CITY OF KIRKLAND
Planning and Community Development Department
123 Fifth Avenue, Kirkland, WA 98033 425.587-3225
www.ci.kirkland.wa.us

MEMORANDUM

Subject: DRAFT POLICY AND CODES FOR PARKPLACE PRIVATE AMENDMENT REQUEST, FILE NO. ZON07-00016

DRAFT CBD 5A USE ZONE CHART

Figure C-4: Downtown Master Plan

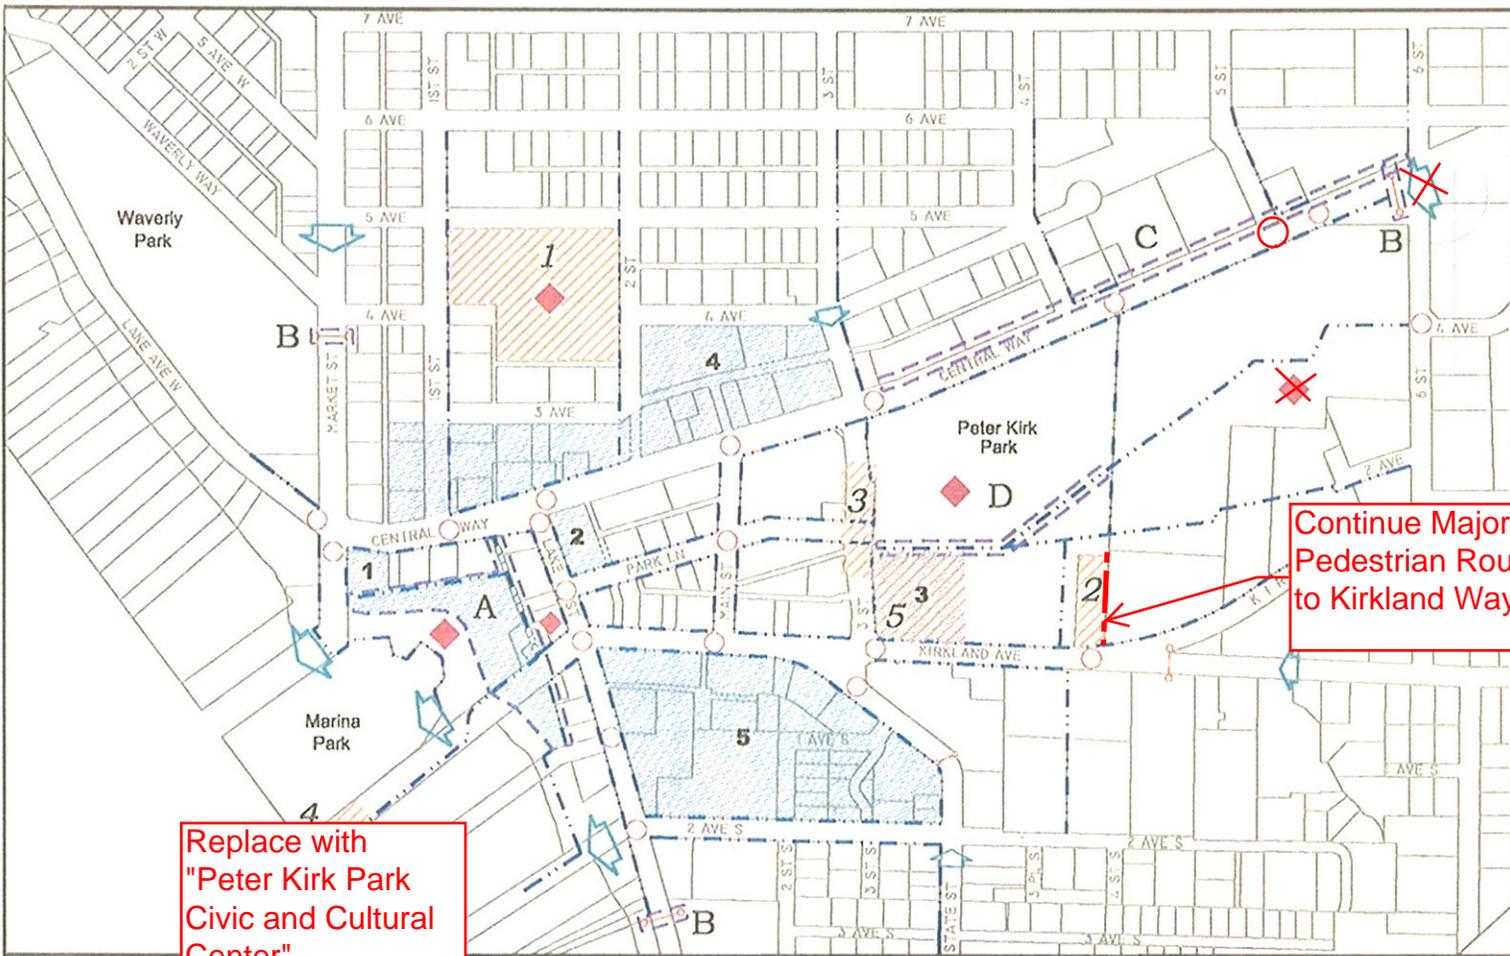
Replace with
 "Peter Kirk Park
 Civic and Cultural
 Center"

Plate X-2

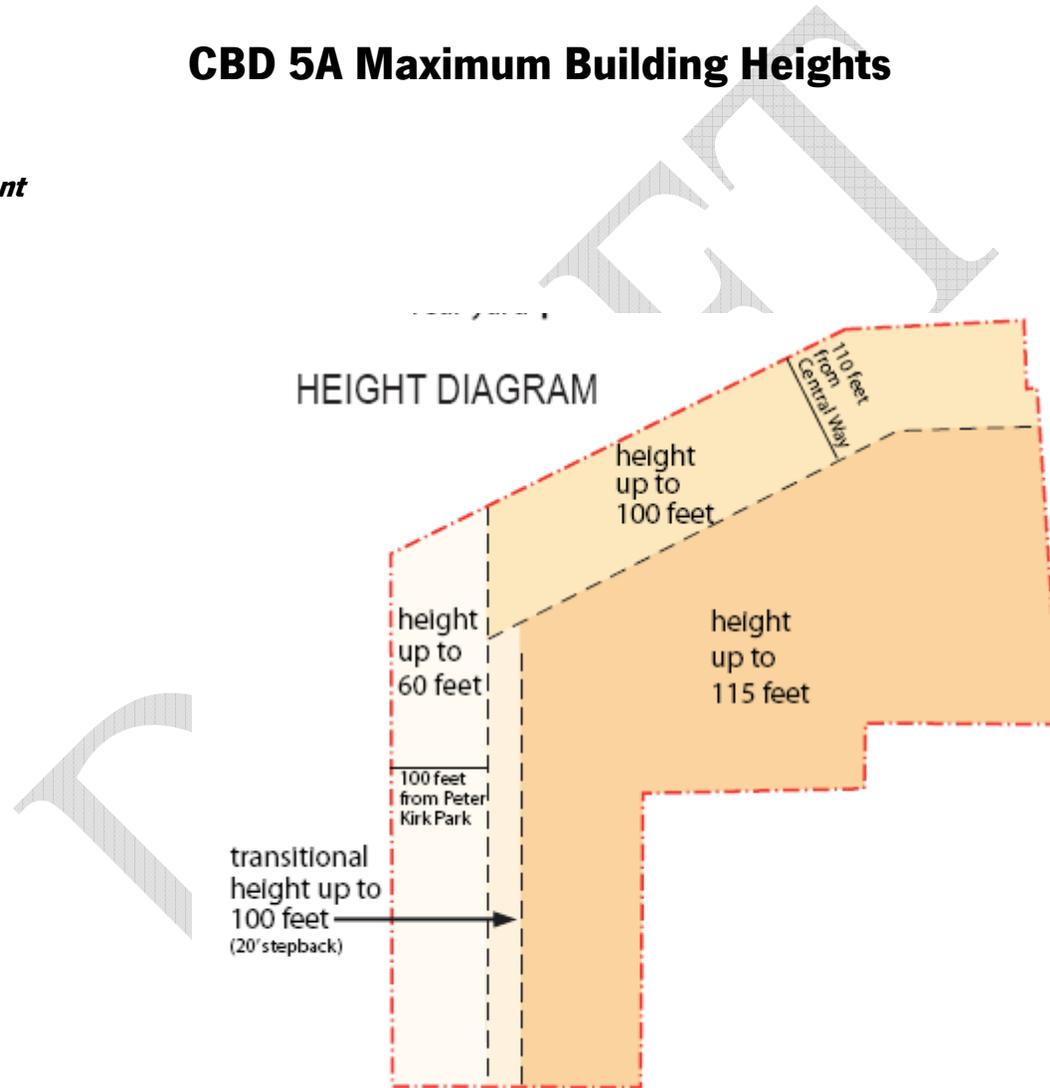
- Rooftop appurtenances (see Special Regulation 5 and Attachment 3): Are the allowances proposed by the applicant acceptable?
- Building Height (see Plate X-2 and Attachment 4): Is the proposed method of calculating maximum building height acceptable?

- Building Stepbacks along Central Way (see Plate X-2): Does the following principle reflect Planning Commission direction?
 - Buildings along Central Way should present a maximum three story mass before upper stories are stepped back. Some averaging of the step backs should be allowed to ensure there is modulation of the facades with some minimum standards to establish a benchmark. Upper story step backs should be measured relative to the stories below (rather than the property line) as follows:

- West of the 5th Street alignment, upper stories should be stepped back between 15' and 20' from stories below.
 - East of the 5th Street alignment, upper stories should be stepped back 10' from stories below.

Staff would recommend that these provisions incorporated into the Master Plan and Design Guidelines document rather than being placed in the Zoning Code. We feel that additional graphics would help articulate the goal and that the DRB should be allowed some flexibility in applying the standard to specific buildings to avoid a rigid, cookie-cutter approach.

BUILDING HEIGHTS: MEASURED FROM WHERE THE MIDPOINT OF THE BUILDING WOULD INTERSECT THE RECREATED GRADE AT THE PROPERTY LINE

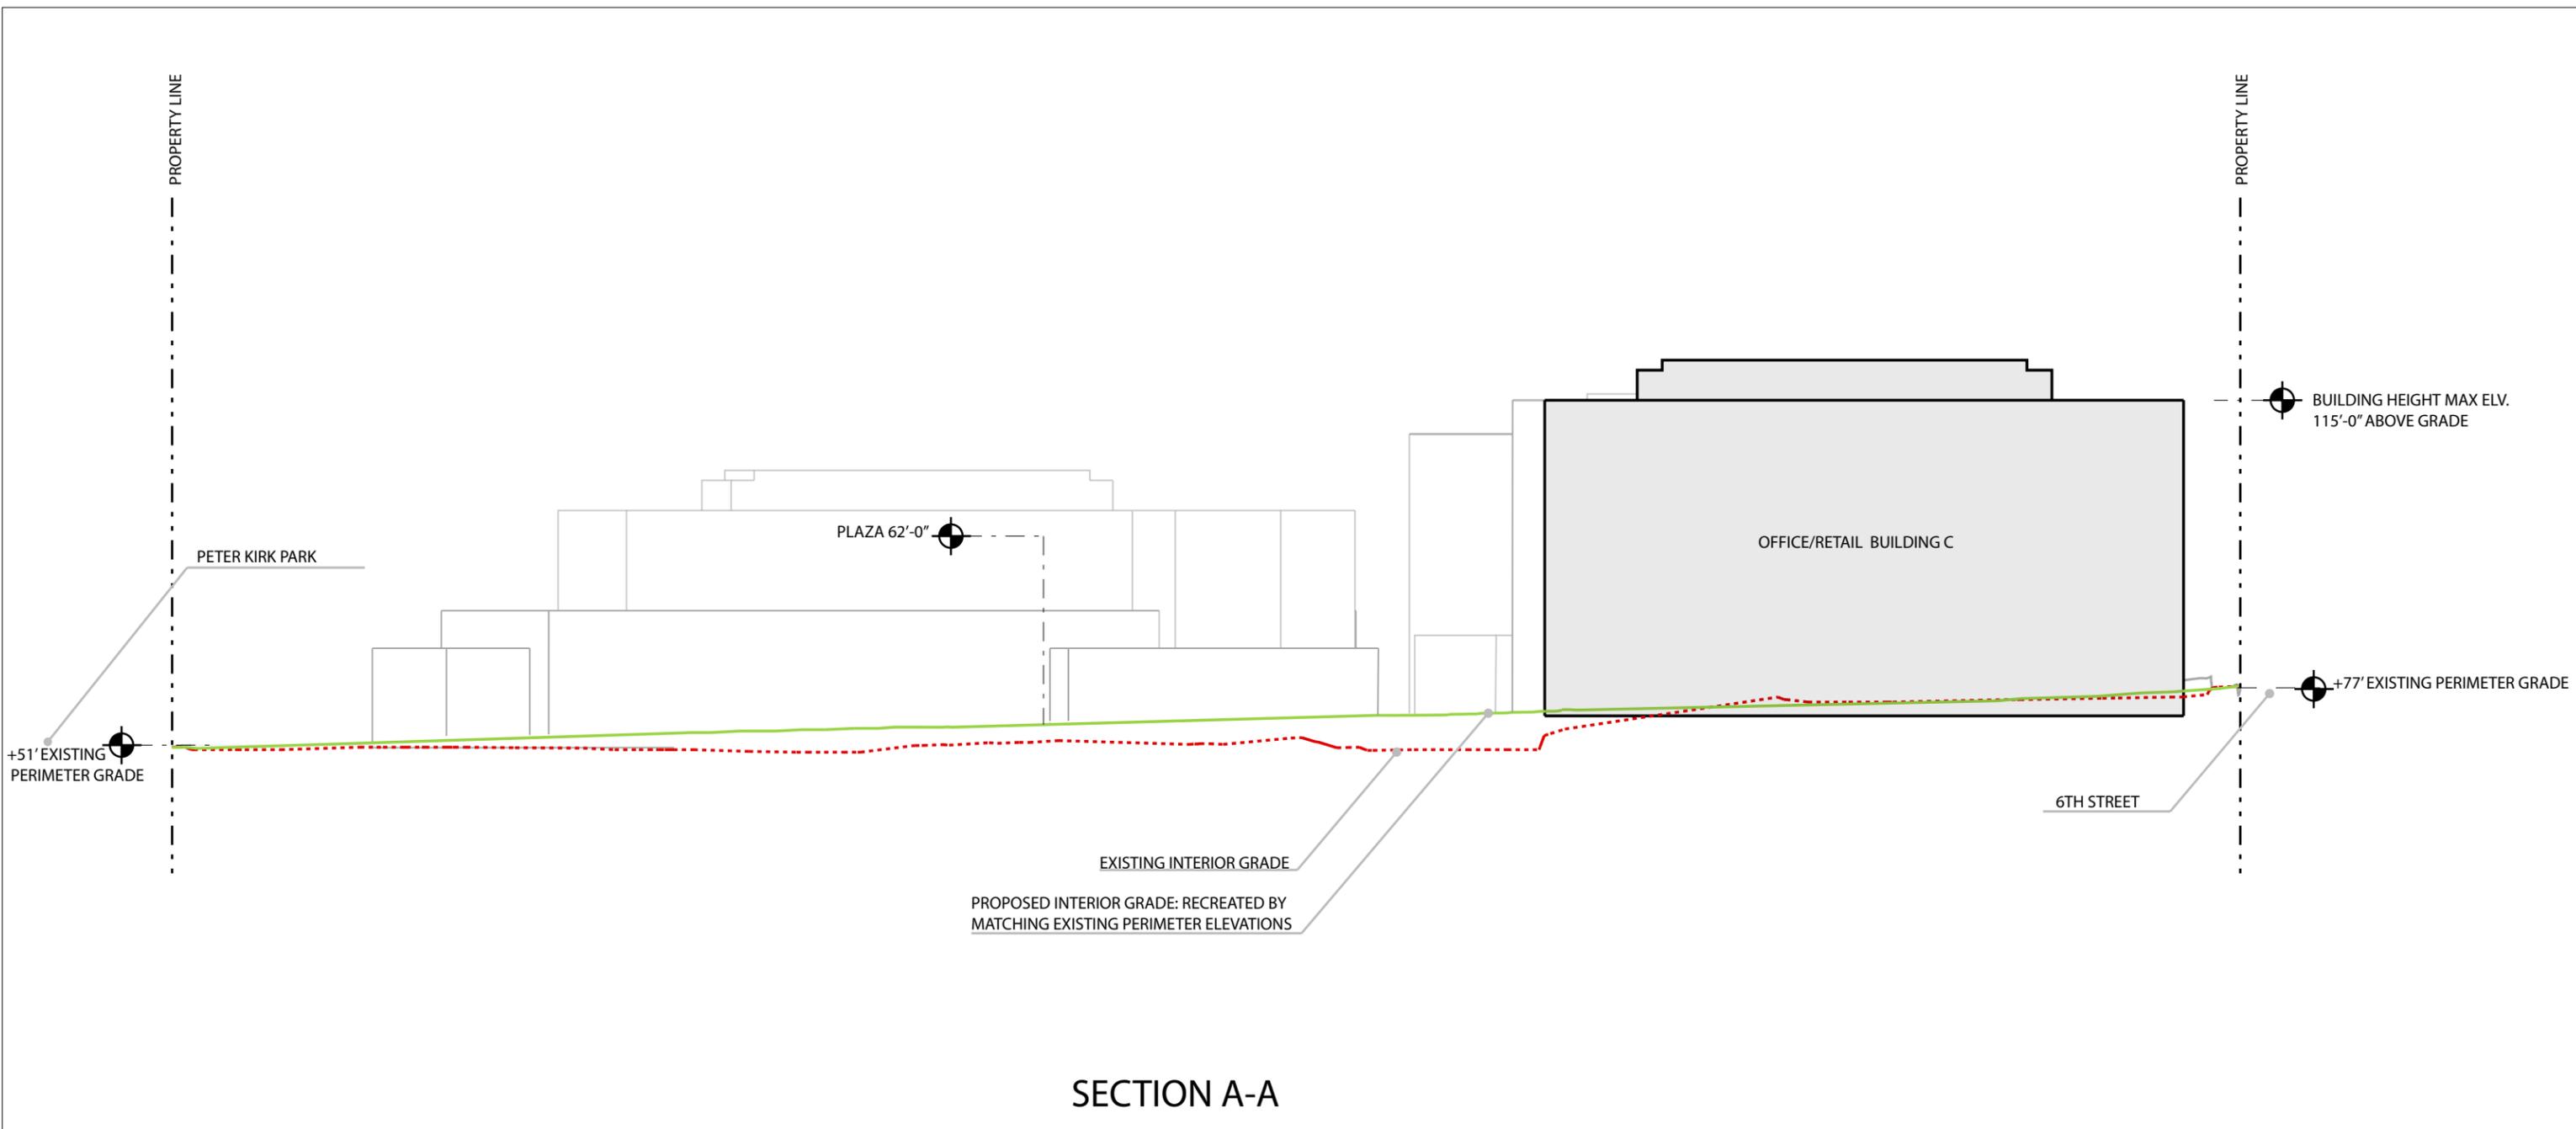
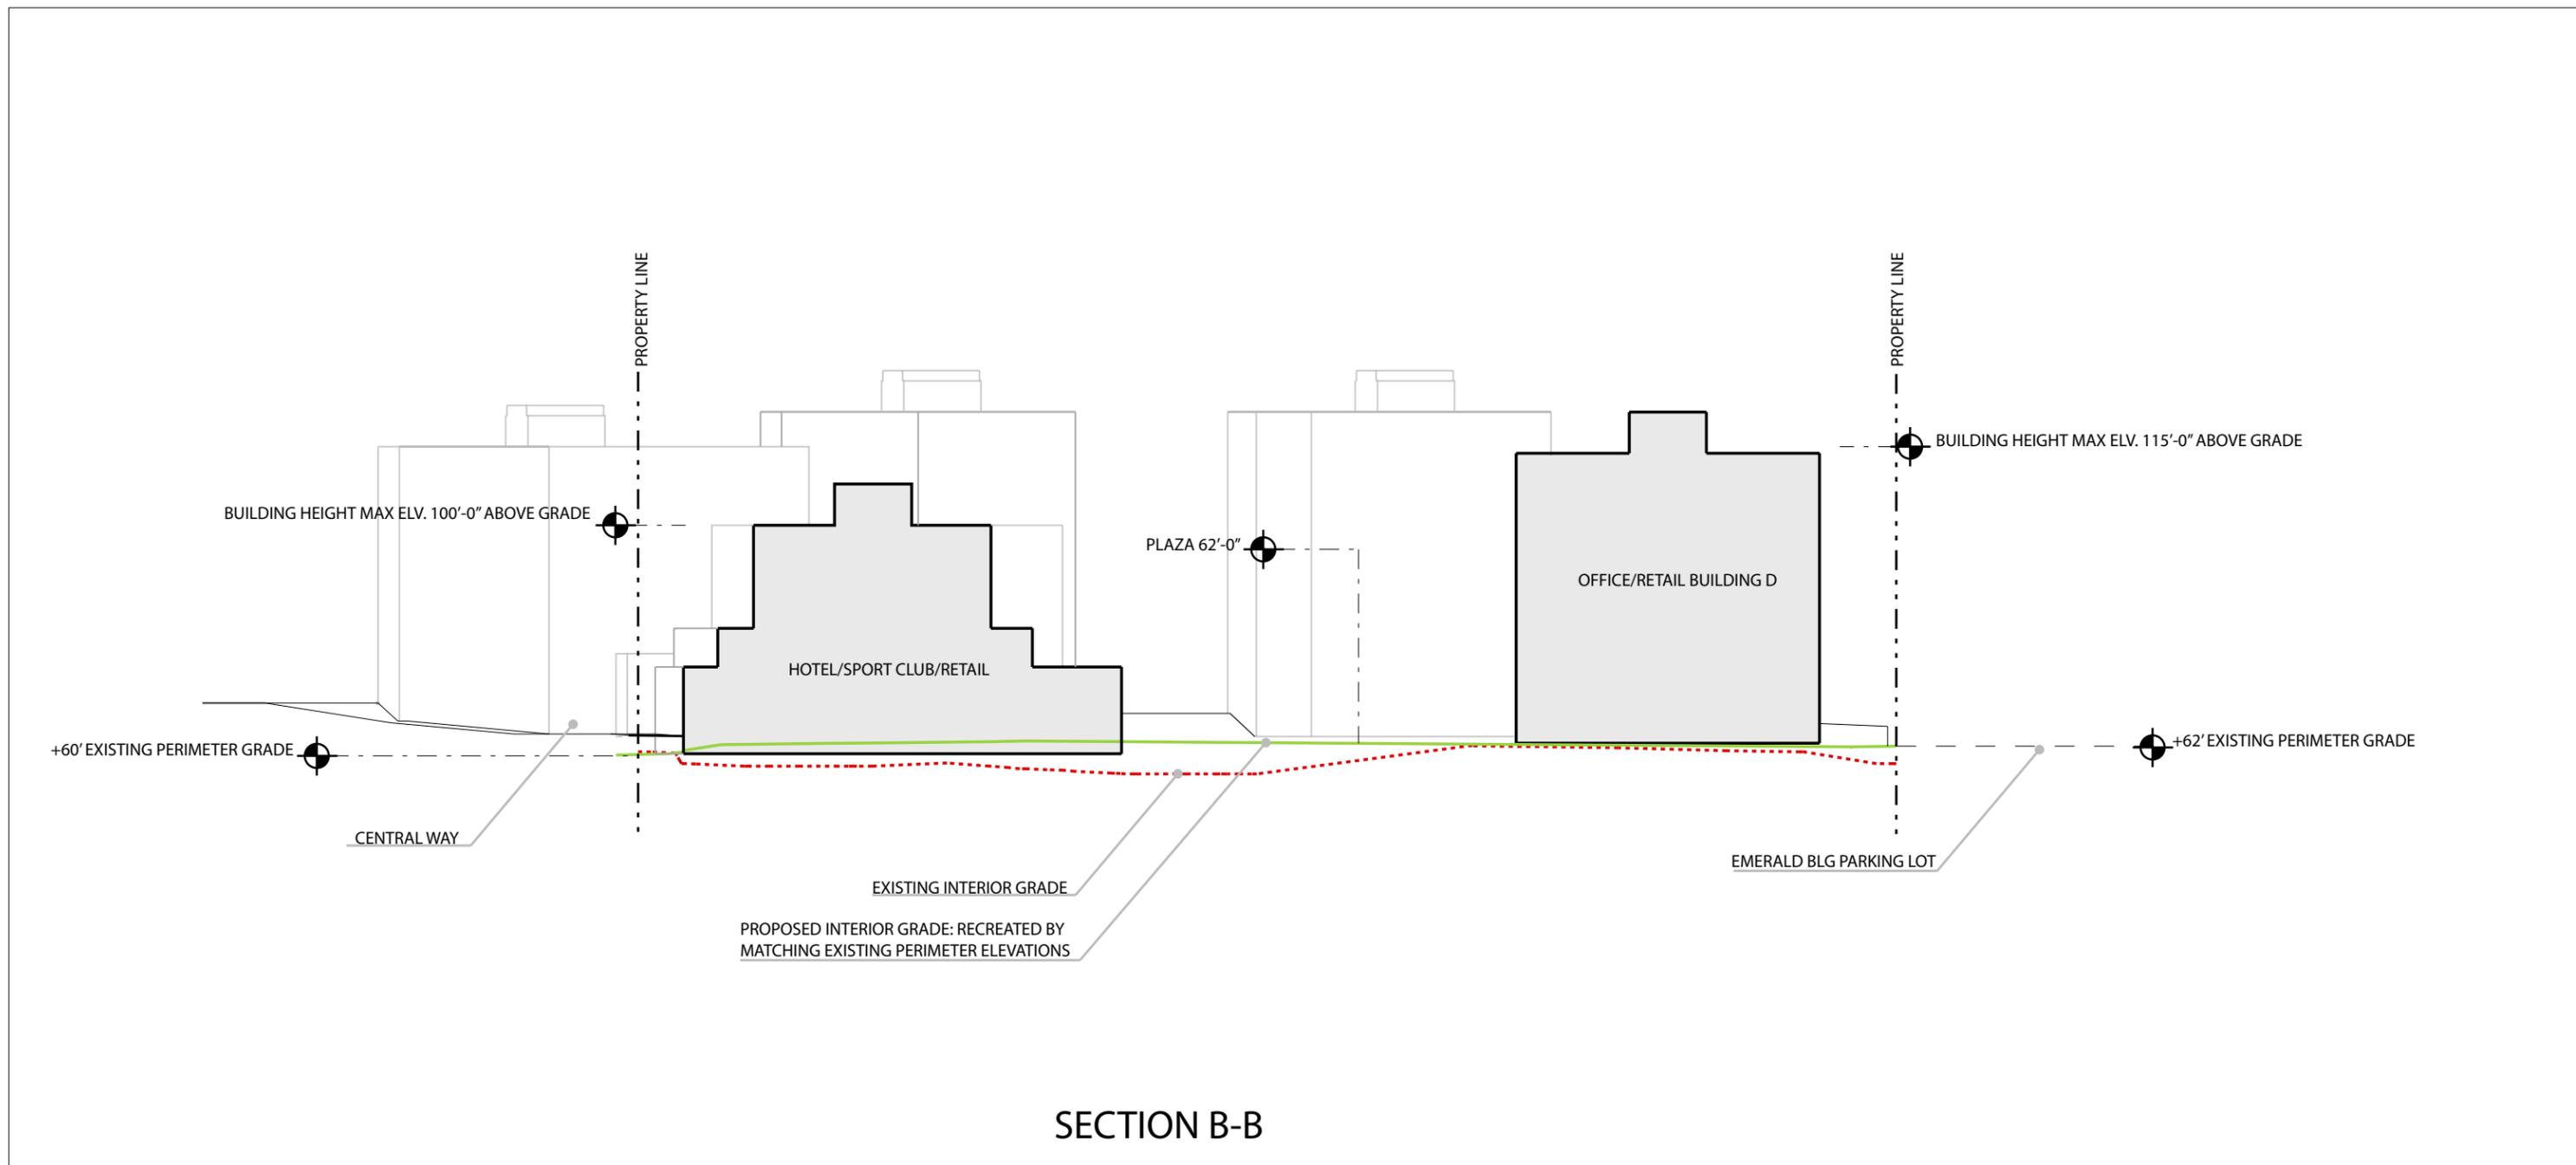
The applicant has provided a site plan and site sections indicating their proposed method of calculating maximum building height in Attachment 4.
